CITY OF MERCED Planning & Permitting Division

STAFF REPORT: #18-08 AGENDA ITEM: 4.1

SUBJECT: Vesting Tentative Subdivision Map #1306 ("Stone Ridge South"),

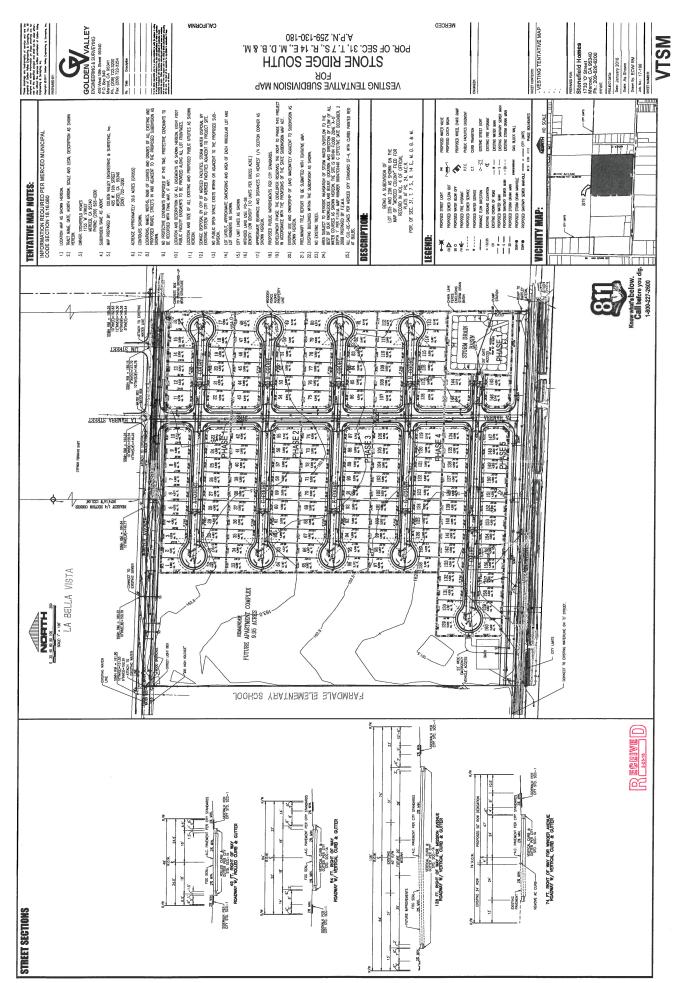
- *10) A permanent emergency vehicle access shall be installed at the end of "I" Court as shown on Vesting Tentative Subdivision Map (VTSM) #1306. The access road shall meet all Fire Department requirements.

- *11) All cul-de-sac bulbs shall have a minimum diameter of 96 feet and shall be posted as "no parking" in compliance with Fire Department Standards adopted by Merced Municipal Code Section 17.32.

- 35) Traffic calming measures, as approved by the City Engineer, shall be installed in the north/south street connecting Winder and Mission Avenues.
- No driveways shall be allowed on the north-south street connecting Winder and Mission Avenue. All driveways shall be placed on the cul-de-sac streets.

Staff expressed concern regarding the extension of La Habra Street as a straight roadway connecting Mission and Winder Avenues. Due to the location of the school to the west of the proposed subdivision, staff feels it is likely that La Habra Street (extended) will be highly traveled during the hours before school starts and when school lets out. It's also likely that vehicles will travel at speeds higher than what would normally be safe within a residential neighborhood. Therefore, staff recommends some type of traffic calming measures be implemented to help mitigate this concern. Condition #35 requires the developer to work with the City Engineer to determine what type of traffic calming measures would be implemented.
